PROPERTY ADDRESS: 13535 Argo Drive

RE: BAT Site Plan comments; 13535 Argo Drive

RE: BAT Site Plan comments; 13535 Argo Drive

**BAT SITE PLAN
 LOT 18
 BUILDING PERMIT NoB15001385
 LINDEN CHAPEL HILLS**

MANIFOLD DETAIL
 NOT TO SCALE

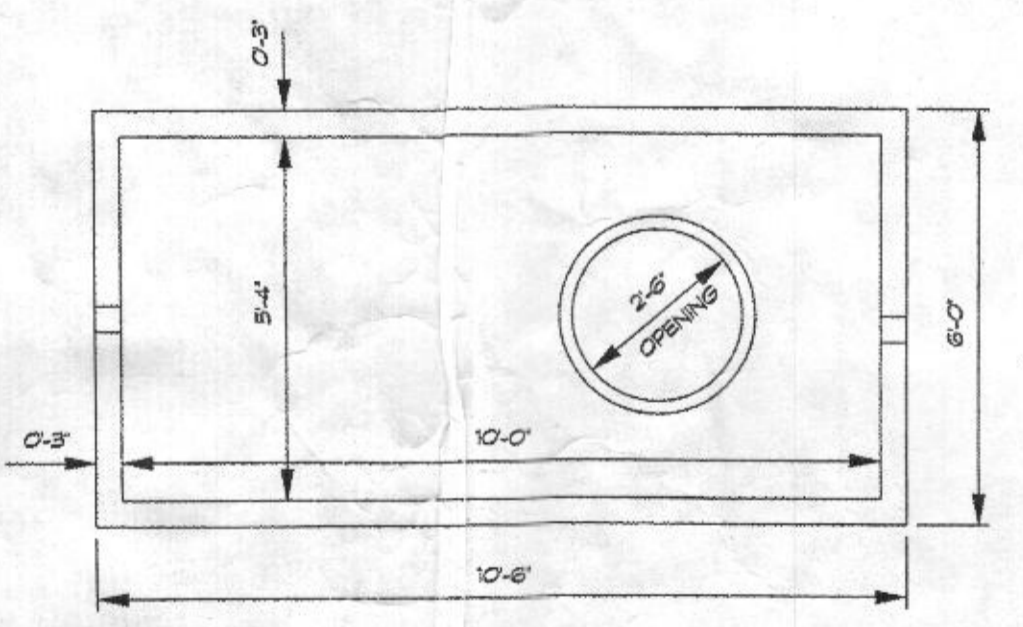
10. In the MANIFOLD DETAIL diagram, the Manifold should be above the Laterals, with 'ell' fittings turning down to the Laterals' 'tee' fittings at the centers of the respective trenches. The Force Main is joined to the Manifold by a 'tee' fitting between the trenches. (The Weep Hole in the Force Main inside the tank will break the siphon when the pump shuts off, and the 20-some gallons of effluent in the Force Main and Manifold will drain through the Laterals.)

1500 GAL. PUMP CHAMBER
 NOT TO SCALE

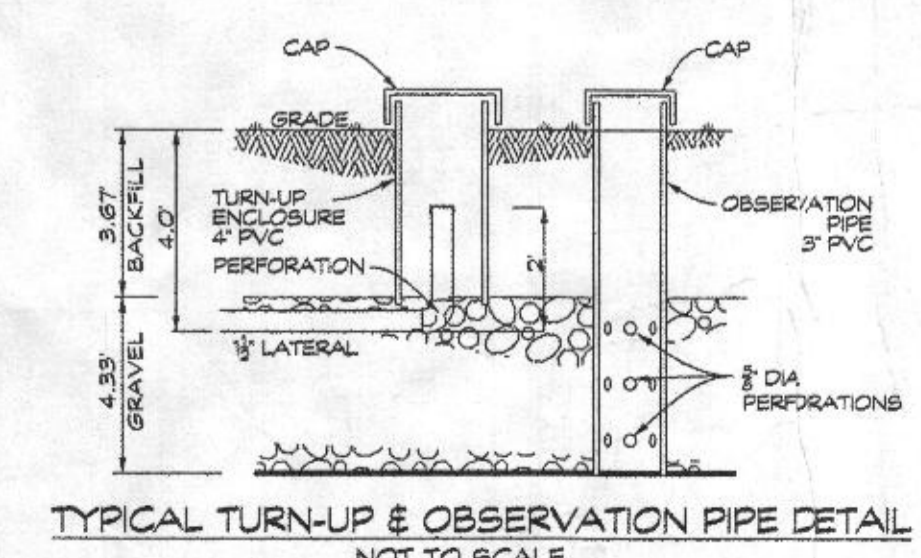
14. For the detail illustration of the '1500 Gallon Pump Chamber', present the illustration of the tank that will actually be utilized. Include the dimension labels for the specified tank, and illustrate float elevations accurately in relation to the calculated volumes.
15. There is a label associated with the pump chamber detail that states that the control panel may be 'in house'. This is incorrect. Edit the statement, deleting "OR INSIDE THE HOUSE" as the Control Panel is never located inside the house.
16. Under 'Specifications' section,
 - a. correct the first statement to indicate ONE specific manufacturer for the 1500-gallon tank to be ordered,
